SUBJECT: Requests hydrostatic testing of identified Inservice Inop
 Class 1 & 2 piping at lower pressures than 1974 ASME Code
 criteria. Avoidance of unnecessary personnel exposure to
 radiation hazards cited. Fee paid.

February 3, 1986
AEP:NRC:0070V

Donald C. Cook Nuclear Plant Unit No. 2
Docket No. 50-316
License No. DPR-74
INSERVICE INSPECTION PRESSURE TEST - CODE RELIEF

DWG. NO. 2-5143-29

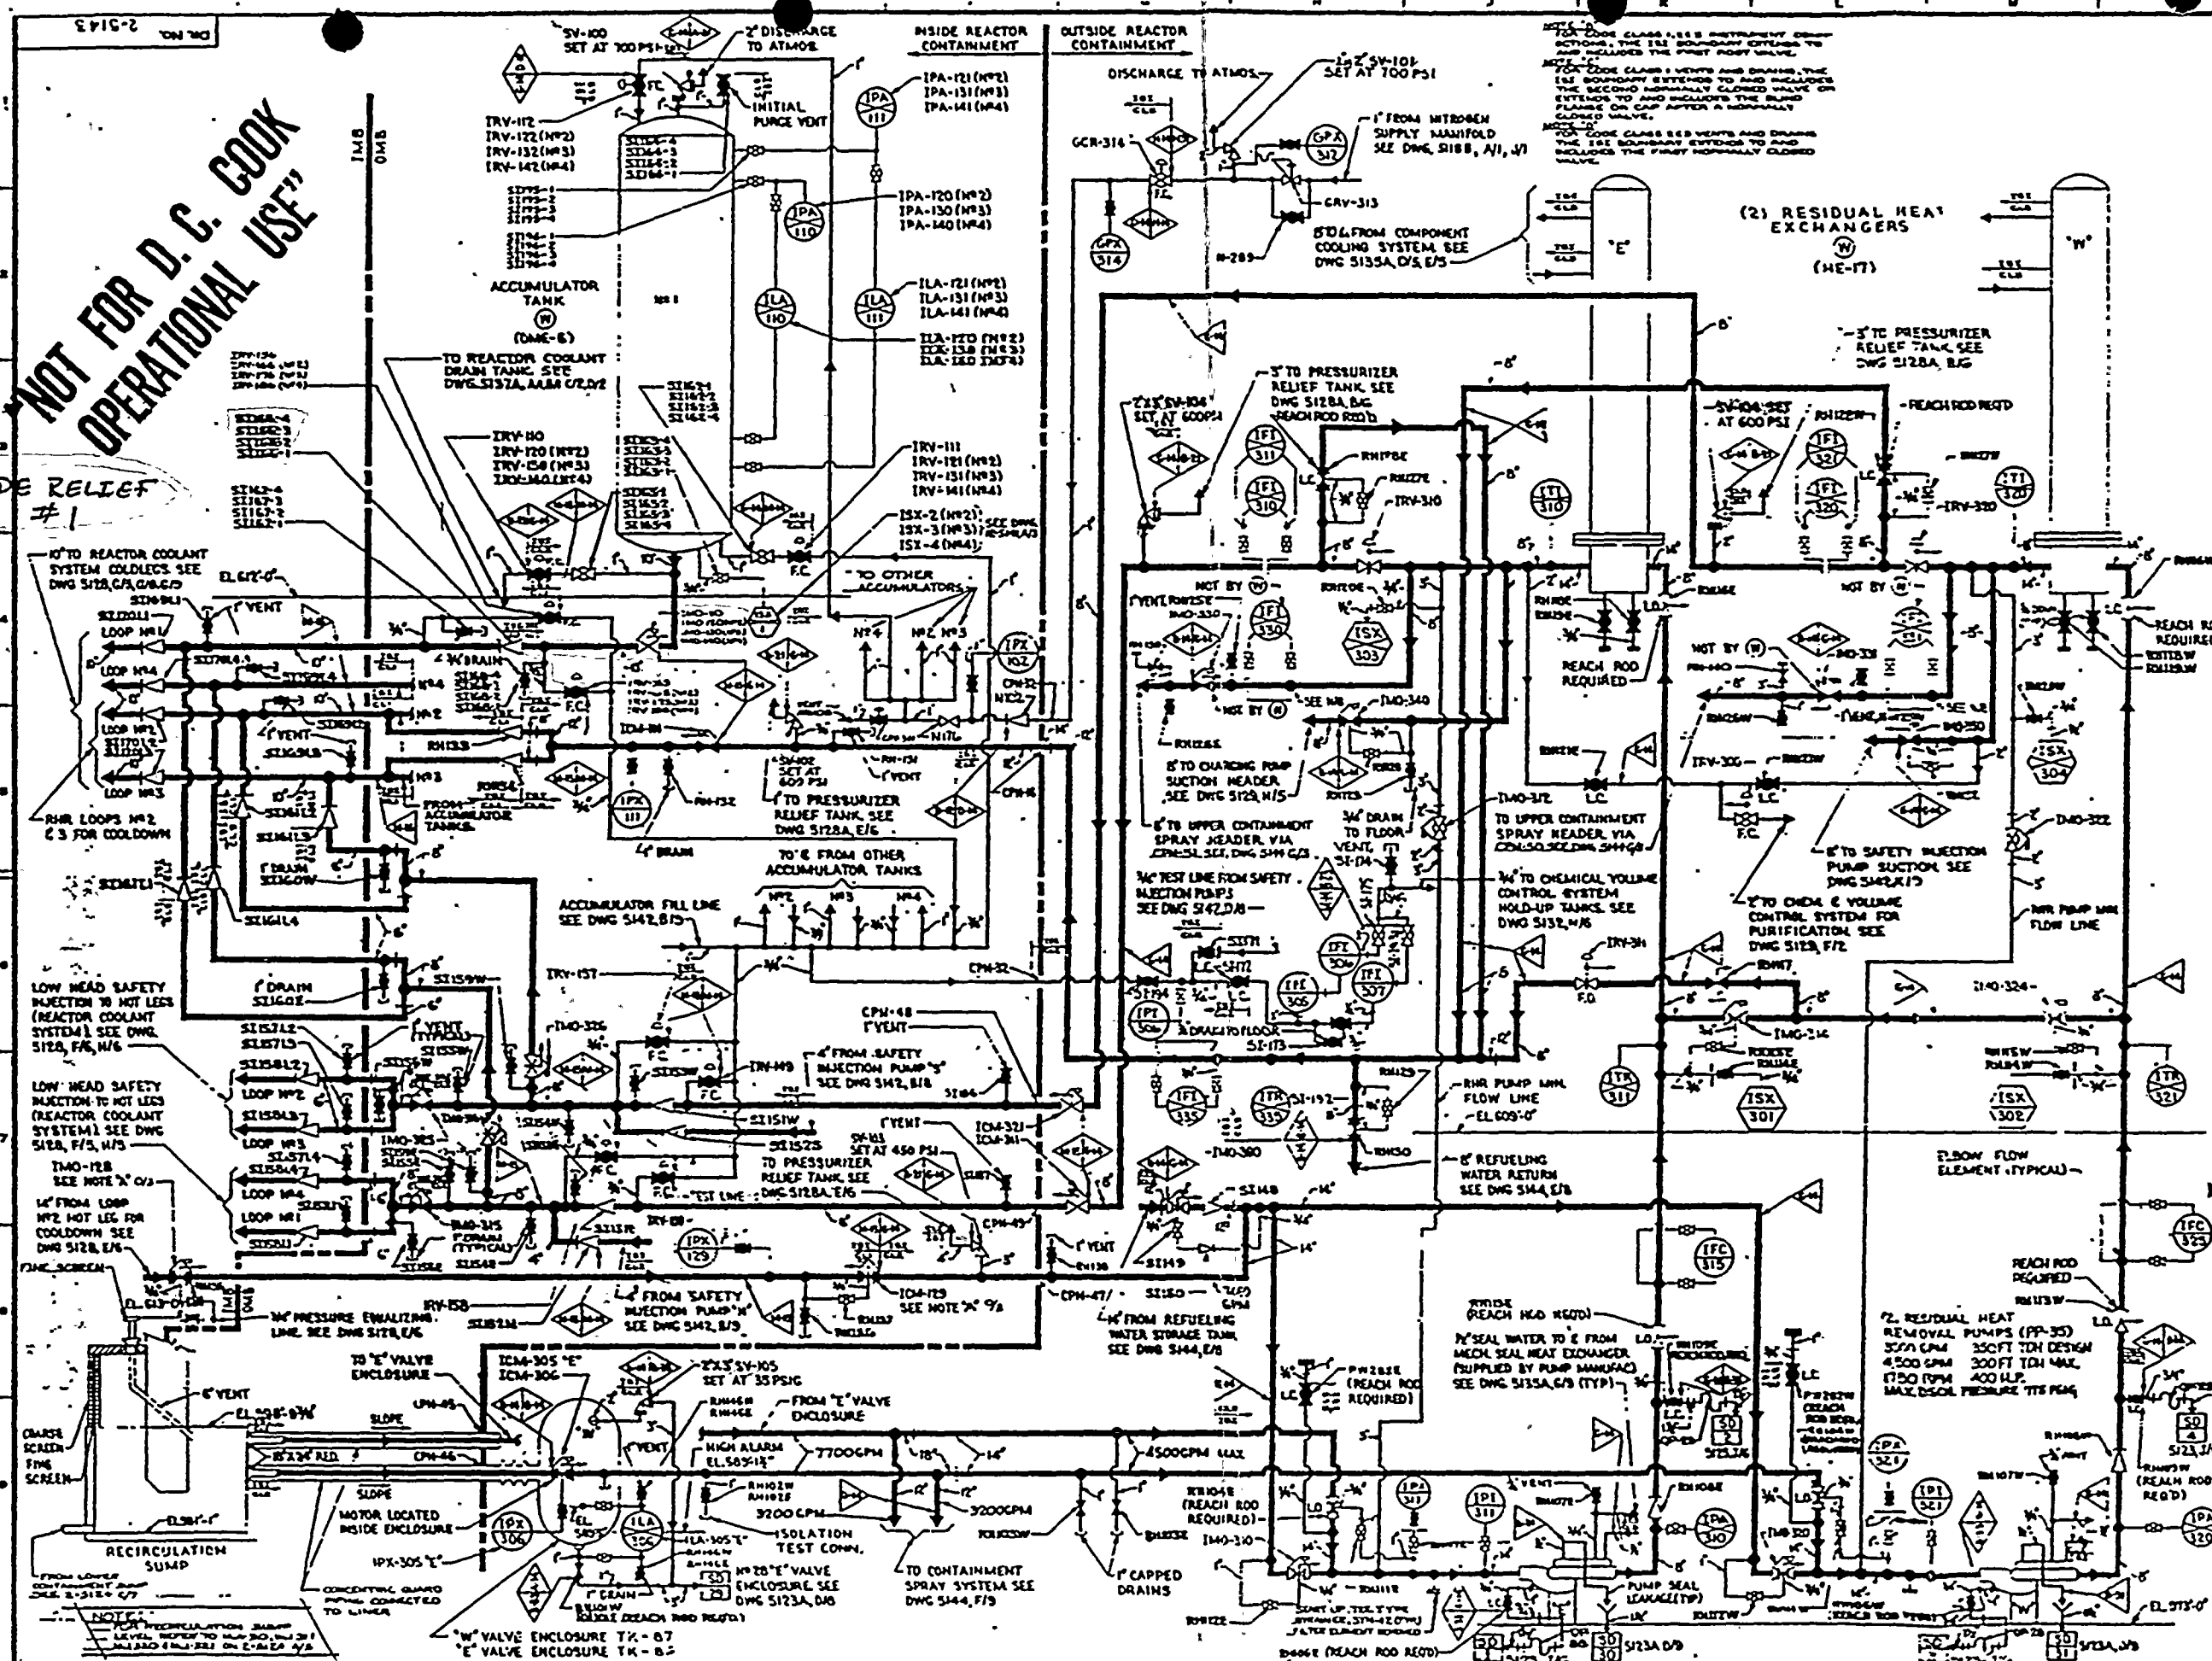
1. Emergency Core Cooling System, Flow Diagram 2-5143 (Attached)

- (a) Accumulator No. 1 Discharge Piping - Valves IMO-110, SI-166-1, IRV-155, SI-168-1
- (b) Accumulator No. 2 Discharge Piping - Valves IMO-120, SI-166-2, IRV-165, SI-168-2
- (c) Accumulator No. 3 Discharge Piping - Valves IMO-130, SI-166-3, IRV-175, SI-168-3
- (d) Accumulator No. 4 Discharge Piping - Valves IMO-140, SI-166-4, IRV-185, SI-168-4

For a system design pressure of 2485 psig, Article IWC-5000 of Section XI code requires the piping to be tested at a pressure of 3106 psig and temperature not less than 100°F.

We propose to test the above sections of piping at a pressure of 2280 psig at a temperature above 100°F. The test will be performed during Mode 3 with the Reactor Coolant System (RCS) pressure at 2280 psig and \geq 500°F. The RCS pressure will be used to block the check valves (SI-166-1, SI-166-2, SI-166-3, SI-166-4) closed, thus limiting maximum pressure to 2280 psig.

The section of piping upstream of check valves SI-166-1 through 4 cannot be tested at a pressure of 3106 psig without making extensive temporary modifications to keep the valves closed. The modifications would require: (1) disassembly of the valves, (2) welding of temporary blocks (on the downstream side) inside the valve bodies to hold a "jack screw" type arrangement to keep the valve closed, (3) removal of the temporary blocking devices from the valves after testing, and (4) performing necessary non-destructive testing to ensure the integrity of the valve bodies before returning them to service. The piping downstream of these valves is part of the RHR System and carries radioactive fluid during normal operation. Therefore, plant personnel would be subjected to substantial radiation exposure and radioactive contamination in order to carry out any modifications for the test.

We believe this to be a reasonable code relief request, since the proposed test pressure is, in fact, higher than the 2235 psig nominal operating pressure in the short sections (less than 5 feet) of the piping systems for which the relief is requested.

DWG. NO. 2-5129-28

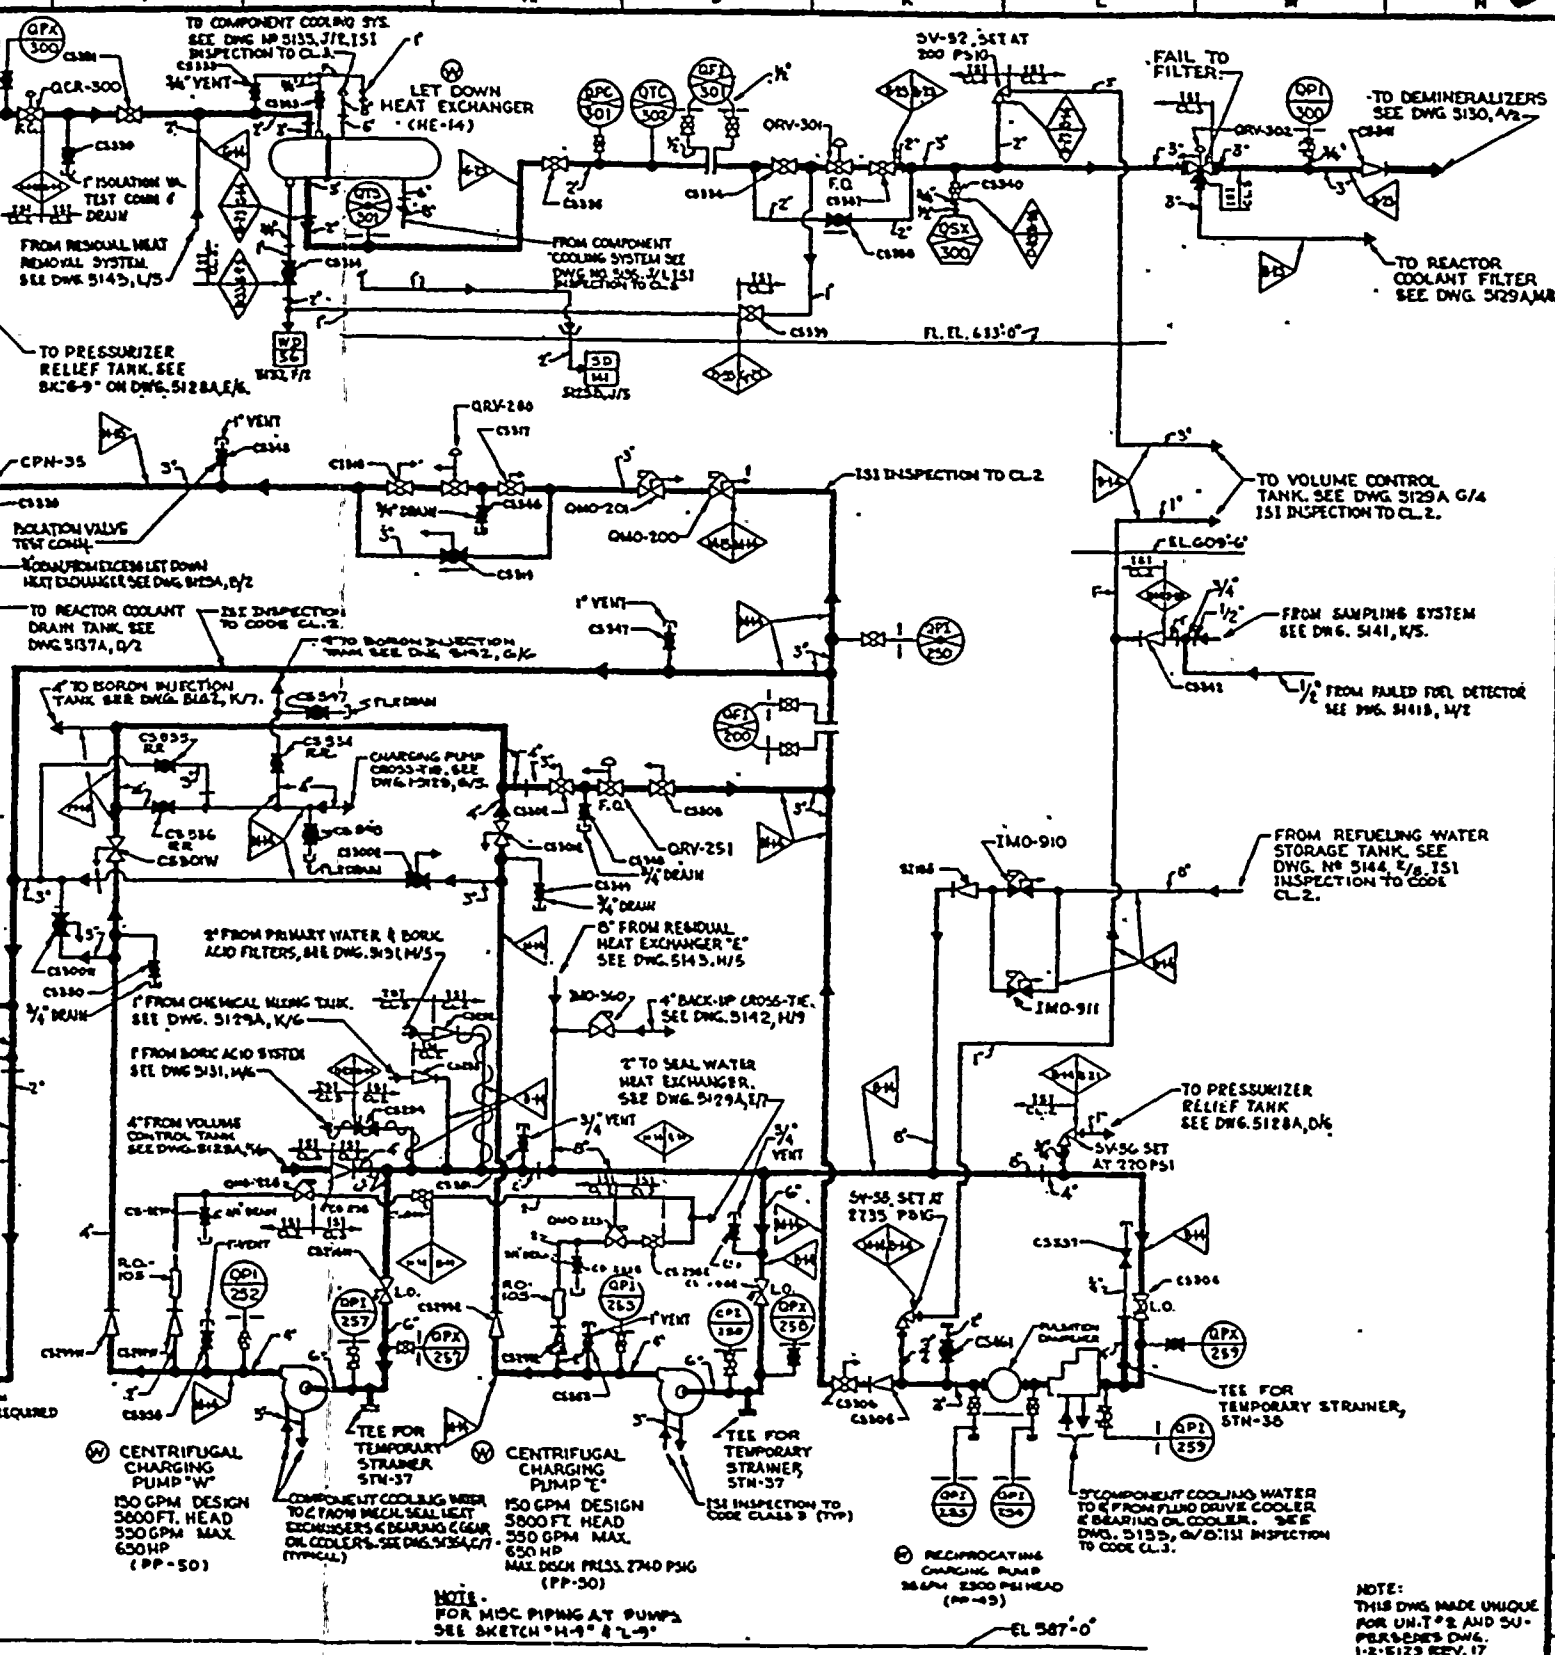
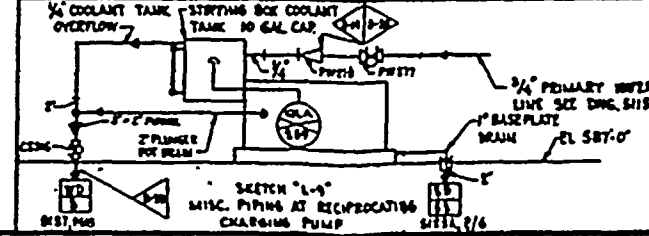
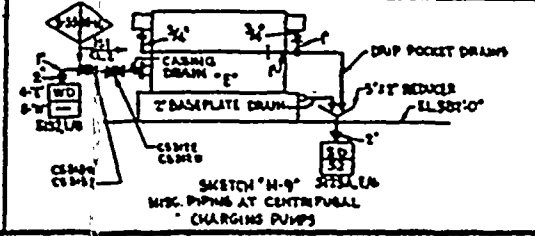
2. CVCS - Reactor Letdown and Charging, Flow Diagram 2-5129
(Attached)

- (a) 2-Inch Aux. Spray Piping -
Valves QRV-51, CS-325
- (b) Normal Charging Loop 4 Cold Leg -
QRV-62, CS-328-L4, CS-326 and CS-327
- (c) Alternate Charging Line to Loop 1 Cold Leg -
Valves - QRV-61, CS-328-L1

For a design pressure of 2735 psig, Article IWC-5000 of Section XI code requires the piping to be tested at a pressure of 3418 psig at temperature not less than 100°F.

We propose to test the above sections of piping at a pressure of 2280 psig at a temperature above 100°F. The test will be performed during Mode 3 with the RCS pressure at 2280 psig and $\geq 500^\circ\text{F}$. The RCS pressure will be used to block the check valves CS-329L1, CS-329L4 and CS-325 closed, thus limiting maximum pressure to 2280 psig.

This is a similar situation to Relief Request No. 1. Check valves CS-328L1, CS-328L4, and CS-325 are located on the charging lines to the RCS System. These valves must be disassembled and temporarily modified to block them closed in order to perform the required hydrostatic tests and plant personnel would be exposed to high radiation and radioactive contamination during the modification.

3. CVCS - Reactor Letdown and Charging, Flow Diagram 2-5129 (Attached)

Valves QRV-112, QRV-160, QRV-161, QRV-162

For a design pressure of 2485 psig, Article IWC-5000 of Section XI code requires the above piping to be tested at a pressure of 3106 psig and temperature not less than 100°F.

We propose to test the above section of piping at a pressure of 2280 psig at a temperature above 100°F during Mode 3 using RCS pressure. Valves QRV-111 and QRV-112 will be opened with QRV-160, QRV-161 and QRV-162 closed.

The above section of piping cannot be tested at a pressure of 3106 psig without modification since no test connection exists. This piping carries radioactive fluid during normal operation. Therefore, plant personnel would be subjected to substantial radiation exposure and contamination in order to add a test connection.

As an alternative, extending the test boundary to QCR-301 was considered. This would involve using QPX-301 located on the downstream piping outside the regenerative heat exchanger room as a test connection. This consideration was also rejected because valve QCR-301 and the flange bolted to the inlet flange of safety valve SV-051 are 600-lb. class, which cannot withstand the above test pressure.

5. Auxiliary Spray to Reactor Coolant System and Pressurizer, CVCS - Reactor Letdown and Charging System, Drawing 2-5129 (Attached)

Valves QRV-51	CS-326
Valves QRV-61	CS-322
Valves QRV-62

For a design pressure of 2735 psig, Article IWC-5000 of the ASME Code, Section XI, requires that the piping be tested at a pressure of 3418 psig, and a temperature not less than 100°F.

We propose to test the above section of piping at a pressure of 2800 psig.

In order to perform the pressure test in this ISI Class 2 Sections of piping, valve QRV-51 has to be used as an isolation valve. This 1,500-lb. class, air-operated control valve is designed to withstand test pressure of 3418 psig in the open position. However, it cannot be used as an isolation valve because it was designed for a differential pressure of 1200 psig.

As an alternative, the possibility of using a freeze seal plug downstream of QRV-51 was considered. This would involve extensive working time close to the pressurizer spray valves, which are in a high radiation area. This alternative was rejected because plant personnel would be subjected to an even higher radiation exposure of 8.5 man rems during formation, monitoring and removal of the freeze seal plug.
